**Residential Center, Auberry: New Residential Center
FINAL
INITIAL STUDY/MITIGATED NEGATIVE DECLARATION
AND
RESPONSES TO COMMENTS**

2020070014

November 2023

**FINAL
INITIAL STUDY/MITIGATED NEGATIVE DECLARATION
AND
RESPONSES TO COMMENTS**

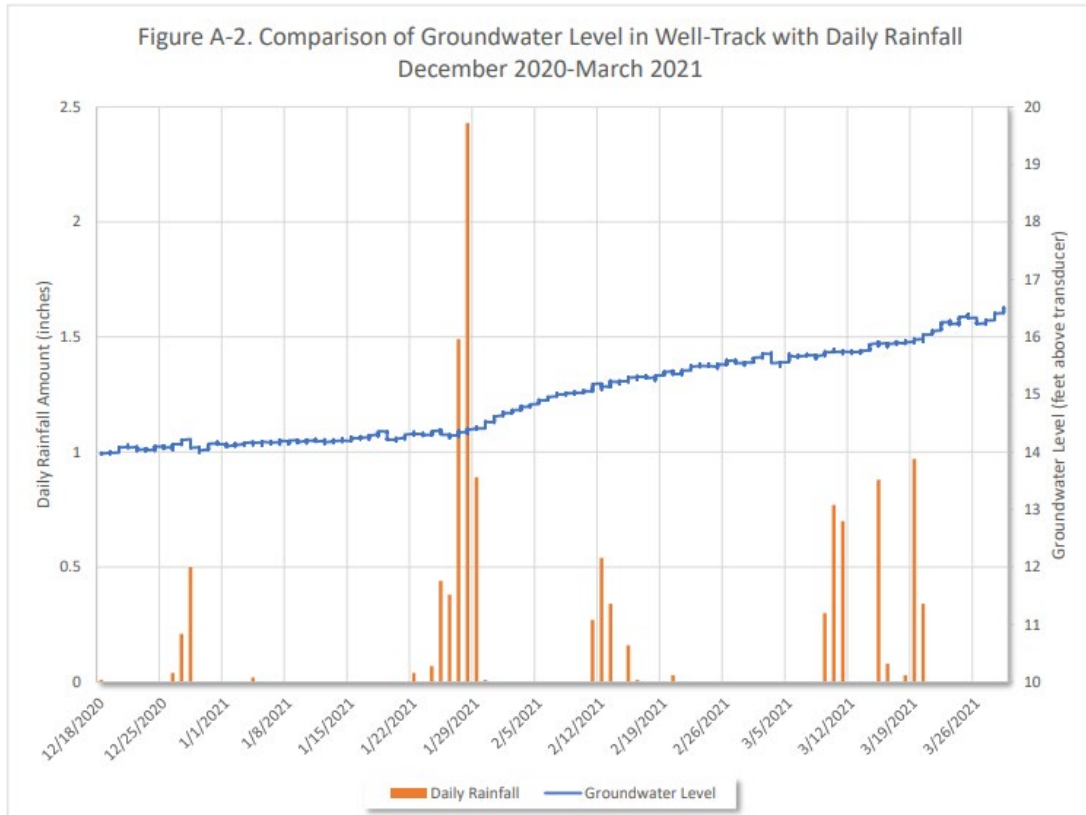
Fact, our records that we furnish to the CA DWR, show our main well pumping level between Jan 2023 and July 2023- static 110 ft and drops to as low as 260 ft pumping level in Feb, 2023. This July recorded 125 ft static - pumping down to 152 ft. in 20 minutes. Both source wells do not pump simultaneously but alternate on timers.

Data and effects from the pumping tests referred to in this comment are discussed and cited five times in the Water Supply Assessment and its Appendix A (which are, collectively, Appendix I of the Draft IS/MND). See citations to *Melvin C. Simons Associates, 2007, Hydrogeologic Analysis, Midland-Pacific Auberry Project, Fresno County, California* on pages 11, 13, 23, and 24 in the Appendix I document.

In conclusion, the pumping tests referred to in this comment were considered in the evaluation and detailed analysis demonstrates that any potential effects from the CCC Auberry pumping would be miniscule compared to the alleged effects from the 2003 to 2006 offsite pumping.
